Public Meeting, Canyonville, OR, December 10, 2015

1                               BEFORE THE  
2                               FEDERAL ENERGY REGULATORY COMMISSION  
3       - - - - - X  
4   IN THE MATTER OF:                               : Project No.  
5   JORDAN COVE - PACIFIC CONNECTOR               : CP13-483-000  
6   PIPELINE PROJECT                               : CP13-492-000  
7       - - - - - X  
8  
9                               Seven Feathers Casino Resort  
10                               146 Chief Milwaleta  
11                               Canyonville, OR 97417  
12  
13                               Wednesday, December 10, 2014  
14       The above-entitled matter came on for technical  
15   conference, pursuant to notice, at 6:00 p.m., Paul Friedman,  
16   the moderator.  
17  
18  
19  
20  
21  
22  
23  
24  
25

Figure 1. Change in intergravel flow of sediment (Reiser and White 1988).

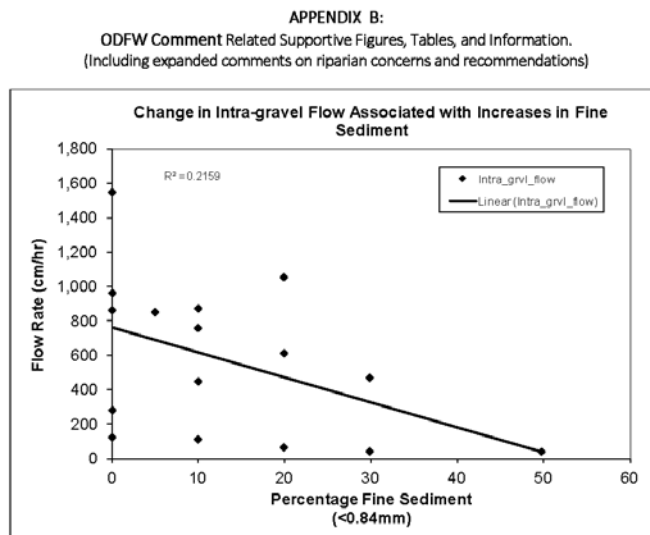
<p>Hall and Lanz 1969; Weiser and Wright 1988; Suttle et al. 2004; Tripp and Poulin 1992; Waters 1995). See Appendix A Figure 1-3.</p> <p><b>Emergency Response:</b> Emergency plans, including immediate notification of turbidity exceedances, frac-outs, spills, and pipeline leaks for both the JCEP facility and PCGP, are considered critically important. Sensitive fish and wildlife habitats can be severely impacted by these types of occurrences. However, impacts can be greatly minimized if remediation actions are initiated quickly upon discovery of an incident.</p> <p><b>Natural Gas Pipeline Shut-Off Valves:</b> ODFW remains concerned with potential impacts to fish, wildlife, and their habitats from unanticipated failures or gas releases: This DEIS should disclose whether it is possible to have a shut-off valve on each side of large stream crossings, such as the South Umpqua, Rogue and Klamath Rivers?</p> <p>Whether if there is a rupture and a natural gas release, how long will it take for the spilling to cease? And How far apart are the proposed shut-offs?</p>	<p>gas release.</p> <p>Should an incident like those described above occur, the project must contact Oregon Emergency Response System immediately (1-800-452-0311) in the case of leaks during pipeline operation or offloading or loading at the JCEP facility or along the PCGP route.</p> <p><b>Natural Gas Pipeline Shut-Off Valves-LNG Control at Large Rivers:</b> ODFW recommends that options to have shut-off valves on each side of large stream crossings such as the South Umpqua, Rogue, and Klamath Rivers be evaluated.</p>

Figure 1. Map of the EFSC site boundary extent and the mapped fault from OGDC-5

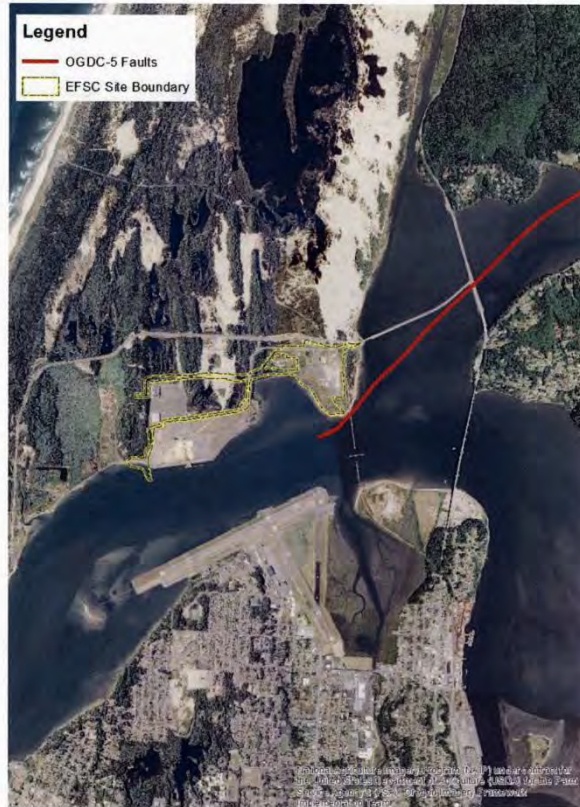
Oregon Geologic Database Compilation (OGDC-5) indicates that a mapped fault exists directly adjacent and/or within the site boundary (Figure 1). No mapped Quaternary faults are identified within or directly adjacent to the site in the Personius et al (2003) database, however, this regional (statewide) fault database should not be solely used to make site-specific conclusions. Both published and unpublished faults should be investigated so that clear conclusions about the possibility of surface fault rupture and other ground failure hazards at the site can be made.

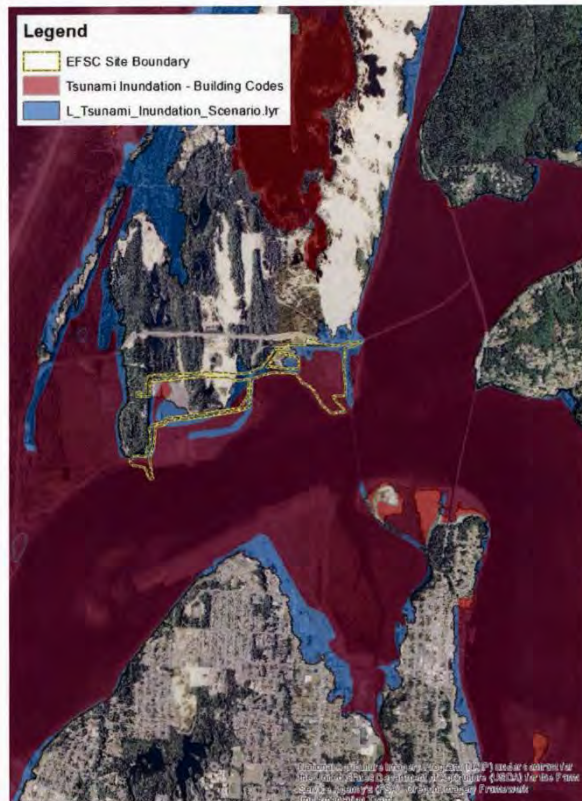
The site is clearly located within the tsunami regulatory map zone (Figure 2; building code). The site is also clearly within the new tsunami inundation hazard maps published by DOGAMI (Figure 2; L tsunami). The applicant should clearly indicate that the site is located within the tsunami regulatory map zone. We recommend reading and complying with the following document <http://www.oregongeology.org/pubs/ofr/OJ-03-05.pdf> and following the current Oregon Structural Specialty Code section 1803 and ORS 455.446 and 455.447.

Figure 3. Map of the current FEMA flood hazard zones (effective, 2009) shown in blue and the zones which are very near becoming effective and probably will become effective in the next several months (preliminary, 2014).

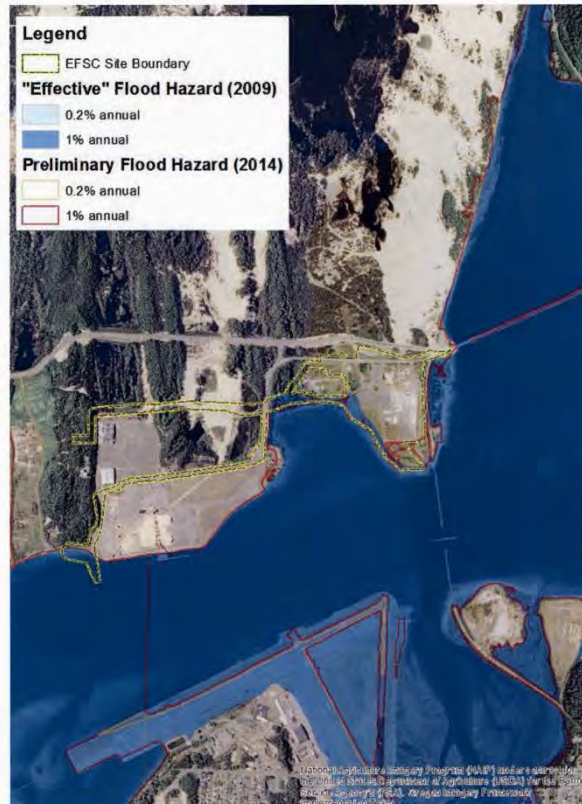
The site appears to have portions located within the current (2009) Effective FEMA Special Flood Hazard Areas (SFHA) (Figure 3) and within the proposed (2014) Preliminary FEMA SFHA. Since the applicant has proposed to place fill on site, possibly within the SFHA, we recommend contacting FEMA Region X (<http://www.fema.gov/region-x-us-usa>) and the Oregon Department of Land Conservation and Development (<http://www.oregon.gov/land/Pages/index.aspx>) to discuss regulations and guidelines associated with any proposed earthwork in the floodplain. We recommend that the proposed fill placement be designed and engineered to avoid the creation of new hazards.
